U.S. Department of Energy
Office of River Protection

04-WTP-268

U.S. DEPARTMENT OF ENERGY (DOE), OFFICE OF RIVER PROTECTION (ORP)
RESPONSES TO THE DEFENSE NUCLEAR FACILITIES SAFETY BOARD (DNFSB)
CONCERNS

Responses to Issues Raised in July 21, 2004 Defense Nuclear Facilities Safety Board (DNFSB) Letter Regarding Waste Treatment and Immobilization Plant (WTP) Ventilation Systems Design

Calc No.: 24590-HLW-SOC-S15T-00009, Rev. 0C

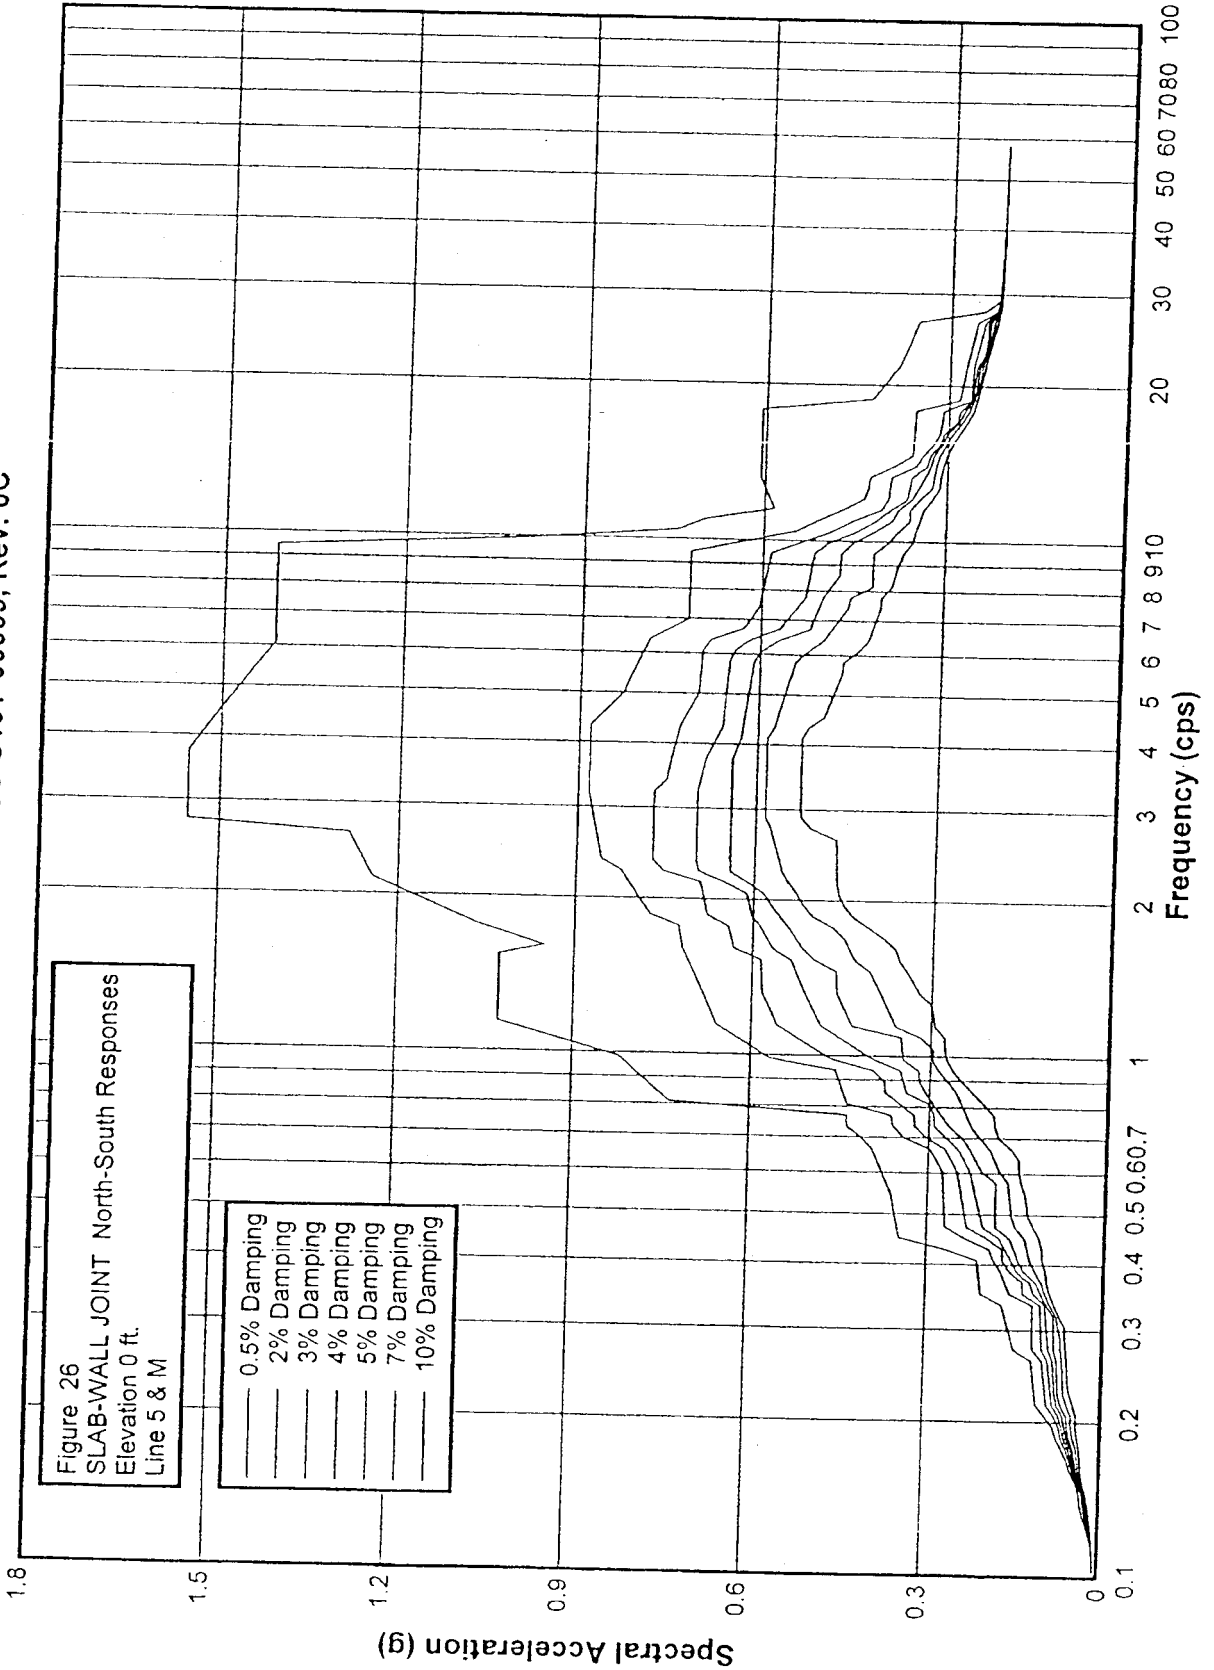
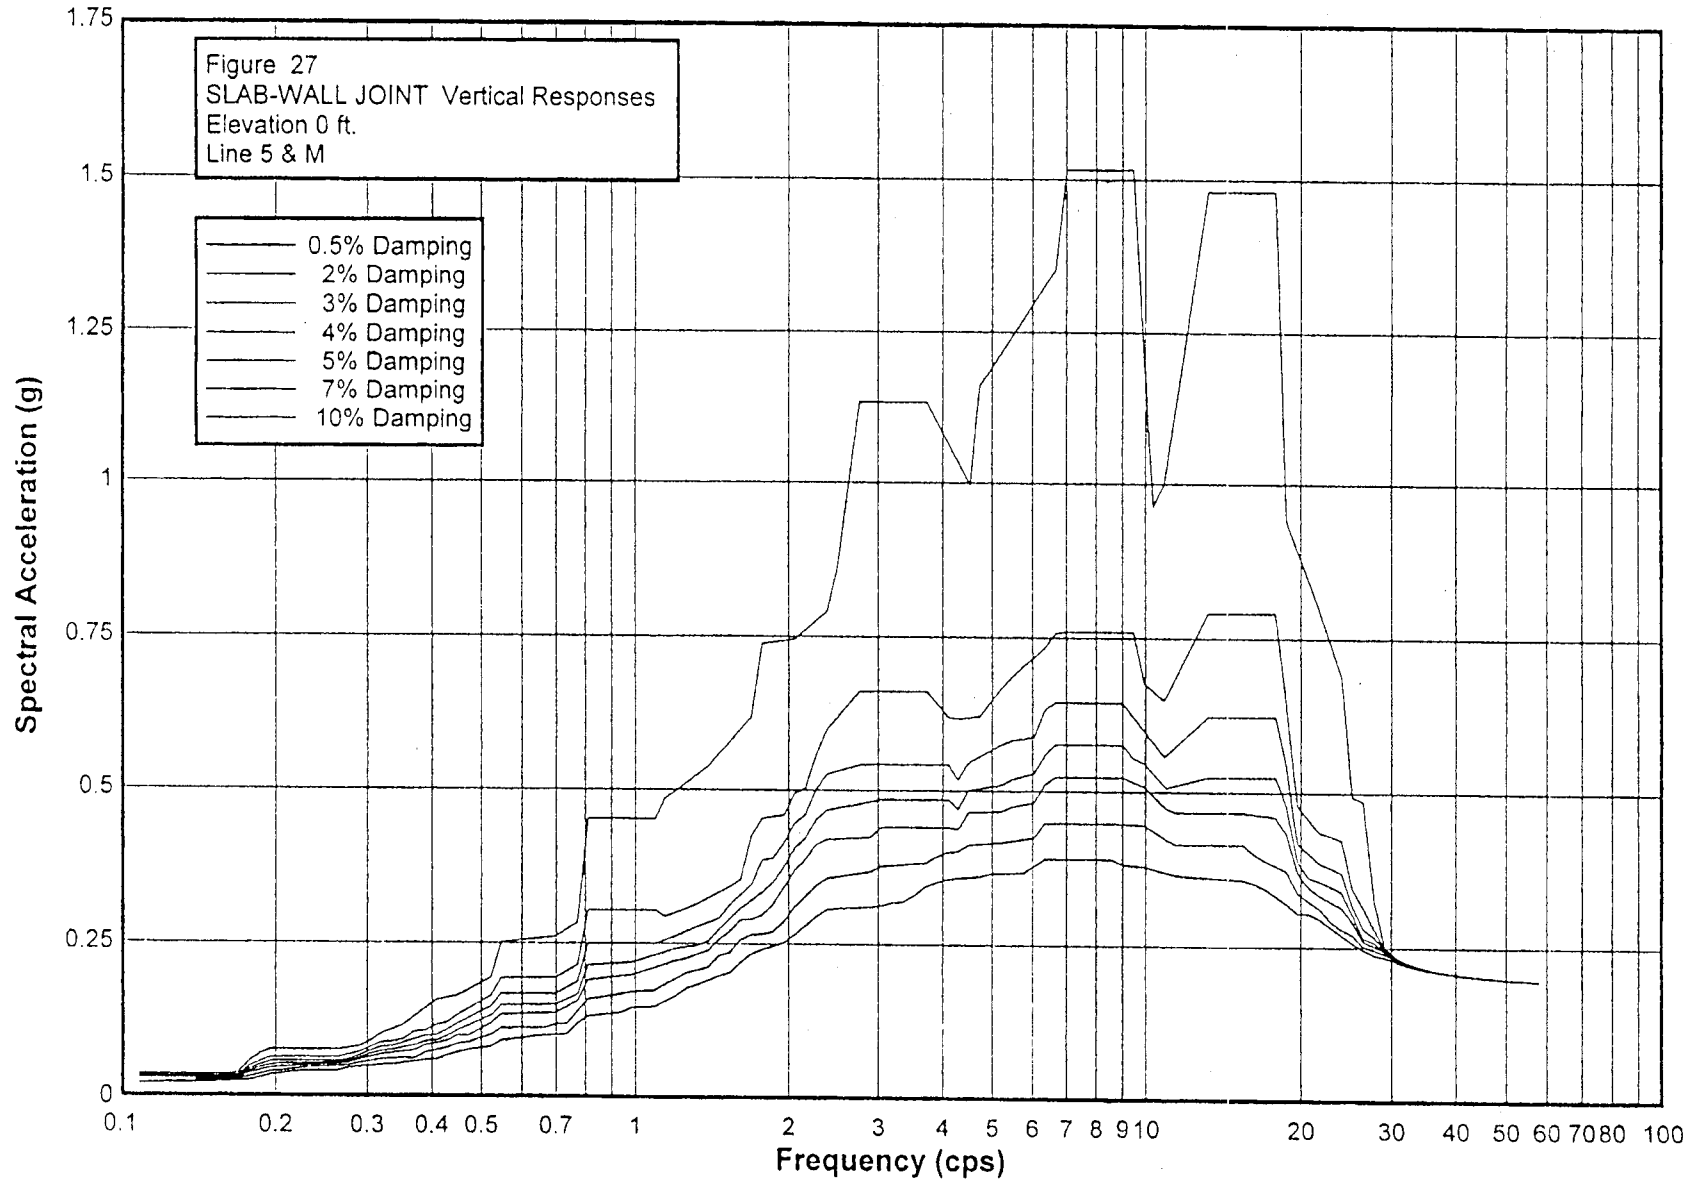
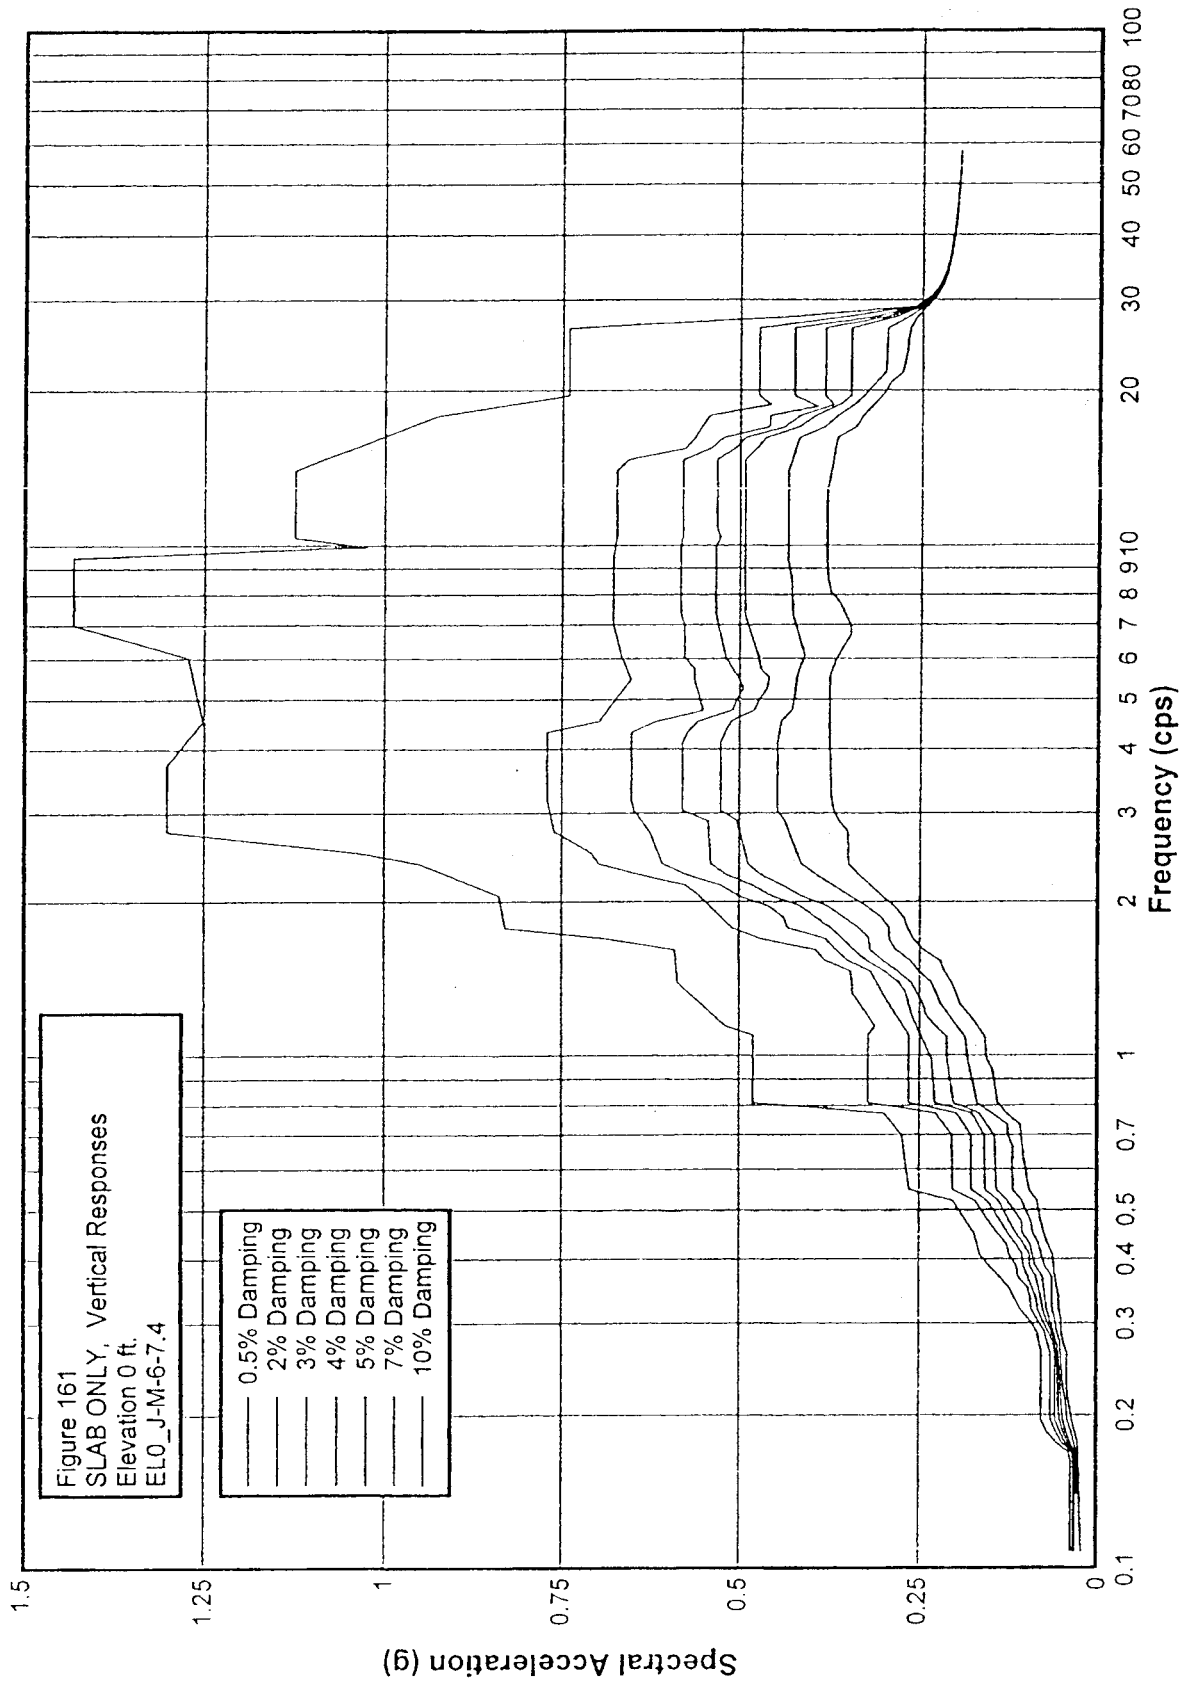
WTP-04-281-02 The planned ventilation filter housing shaker table tests will use a bounding seismic spectra as input for the shaker table tests. The staff wants to review the bounding data for suitability.

Response: The WTP Project will not use bounding data for the PT and HLW facilities. The specific In-Structure Response Spectra (ISRS) curves for each facility will be used and separate testing for each facility will be conducted. The applicable curves, by elevation and column line, for the Remote Change HEPA Filter housings will be used which shows the expected frequencies and accelerations in the north/south, east/west, and vertical directions. The reason for applying the ISRS curves specific to each building and not using bounding data is as follows:

The Remote Change HEPA Filter Housings in the PT and HLW buildings will require separate testing for the following reasons:

- a) The housings are supported by steel platforms. Since the platforms are not rigid, they need to be simulated for testing. The platform configurations are different. Therefore, their simulations would be different, requiring separate testing.
- b) ISRS for PT and HLW buildings are different.
- c) It is likely that the external loads on the housings, e.g., connected ducts, in PT could be different from those in HLW.

Enclosed are the ISRS curves applicable to the Remote Change HEPA Filter housings in the HLW and PTF facilities.†
